<b>Derby Diocesan Association of Church Bellringers Consultant's Report</b>	<b>Report no. DDACB 10/003</b>
<b>All Saints', Brailsford Feasibility Study For Improvement of Rope Circle</b>	<b>Issue date: 25/07/003</b>

FIGURE 1  
RINGER'S GALLERY - EXISTING ROPE CIRCLE

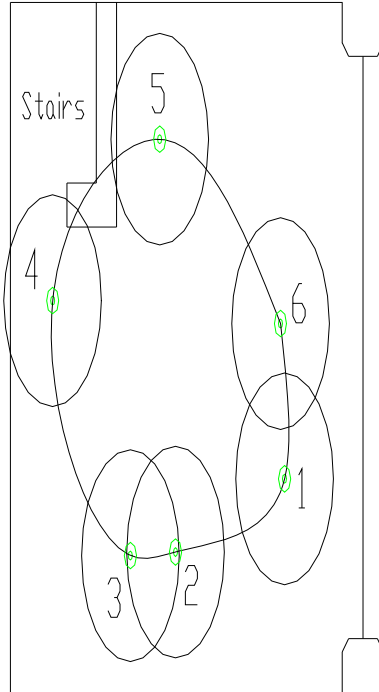
- Figure 1 shows that removal of the rope guide has caused the ropes for bells 2 and 3 to fall too closely to each other. (The circles represent recommended safety zones of radius 600 mm around each rope, which should be largely clear of any obstructions. This allows space for personnel to ring safely (particularly when under tuition) without unduly interfering with neighbouring ringers).

- The ringer of bell 4 blocks entry to the gallery from the spiral staircase. This is dangerous for both the ringer and any newcomer attempting to gain entry when ringing is in progress.

- When ringing is in progress it is essential that each ringer has a clear view of the ropes of each of the other ringers. This is achieved by ensuring the ropes fall essentially in a circle, certainly avoiding any tendency for ropes to be in a straight line. Figure 1 shows that ropes 1, 2 and 3 are close to being in a line making rope sight difficult for ringers in these positions.

FIGURE 2  
RINGER'S GALLERY - PROPOSED NEW ROPE CIRCLE

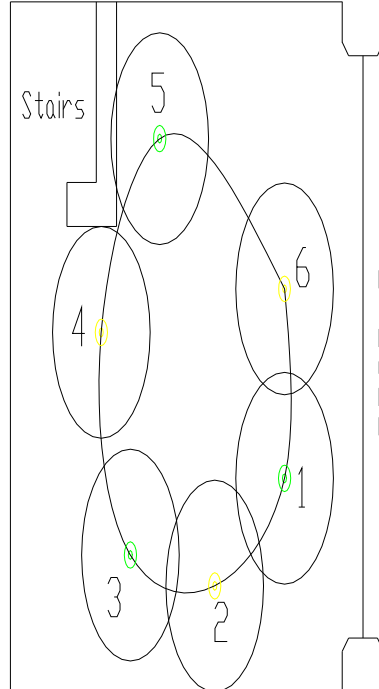
Figure 2 shows that repositioning the ropes as follows will give an acceptable rope circle.

- Rope 2 is moved to a position which is equidistant from ropes 1 and 3 and also 600 mm from the south wall. (This removes the safety hazard and improves rope sight between positions 1, 2 and 3).
- Rope 4 is moved to a position which is equidistant from ropes 3 and 5 and also 600 mm from the spiral stair balustrade. (This removes the safety hazard and gives a more circular rope circle).
- Rope 6 is moved 200 mm northwards away from rope 1 (it appears that rope 6 does not fall truly vertical through the intermediate room and this movement will not only give less overlap of safety zones between ropes 1 and 6 but will also allow rope 6 to now fall vertically).
